Access Compliance Report

Public Rights-of-Way

(Curb Ramps)

Intersection ID: 11255	Main Street: ATTABERRY_DR	Cross Street: MATHESON_AV	Location: W
ADA ID: 3E1EB1972C48	Ramp Type: PerpDiag	Initial Pass/Fail: Fail	Overall Compliance: No
		Severity Score: 22.5

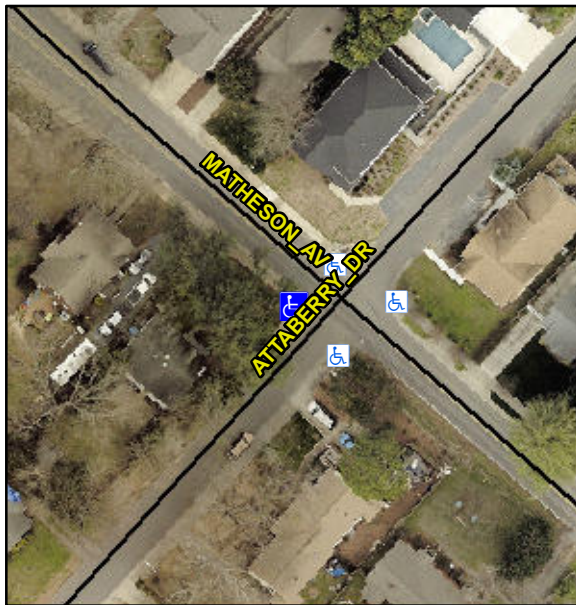
Not Found, R304.5.1, R304.2.2, R304.5.3

Compliance	Description	Data	Compliance	Description	Data
N/A	Ramp Length (in)	59.5	No	Ramp Slope (%)	9.1
No	Ramp Width (in)	41.0	No	Ramp XSlope (%)	4.2
N/A	Flare Type LT	N/A	N/A	Flare Type RT	N/A
N/A	Flare Slope LT (%)	N/A	N/A	Flare Slope RT (%)	N/A
N/A	Flare Traversable LT?	N/A	N/A	Flare Traversable RT?	N/A
N/A	Landing Length (in)	N/A	N/A	DWS Provided?	N/A
N/A	Landing Width (in)	N/A	N/A	DWS Contrast?	N/A
N/A	Landing Slope (%)	N/A	N/A	DWS Length (in)	N/A
N/A	Landing X Slope (%)	N/A	N/A	DWS Full Width?	N/A
N/A	Landing Curb? (Y/N)	N/A	N/A	DWS Offset (in)	N/A
N/A	Shared Landing?	N/A			
N/A	Gutter Ponding?	N/A	N/A	Gutter Slope (%)	N/A
N/A	Gutter Lip Ht (in)	N/A	N/A	Gutter X Slope (%)	N/A
N/A	Painted X Walk1?	No	N/A	Painted X Walk2?	No
	X Walk 1 Direction	To SE		X Walk 2 Direction	To NE
N/A	X Walk 1 Width (in)	N/A	N/A	X Walk 2 Width (in)	N/A
	X Walk 1 Slope (%)	0.0		X Walk 2 Slope (%)	2.3
	X Walk 1 X Slope (%)	0.4		X Walk 2 X Slope (%)	2.9

Remove & Replace Curb Ramp With Two New Directional Ramps or Equivalent.
